DEVELOPMENT APPLICATION ASSESSMENT REPORT

DA2022/0925

This report is submitted to the Northern Beaches Development Determination Panel (DDP) for consideration of Development Application DA2022/0925 for alterations and additions to an existing attached dual occupancy to create a dwelling house, including an upper floor addition to the building.

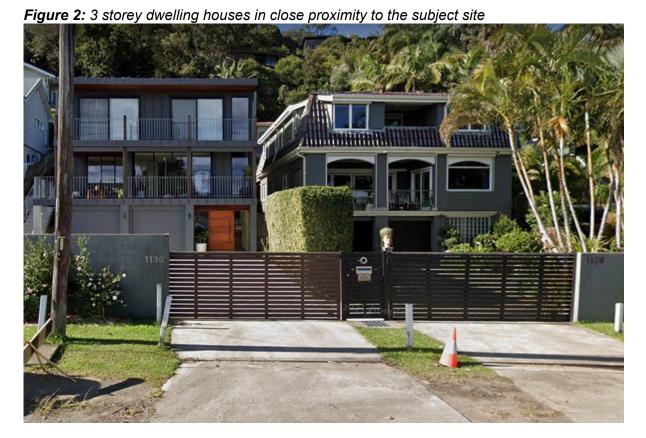
Comment:

The building appropriately steps up the land, while including a roof line that sensitively responds to the slope of the land.
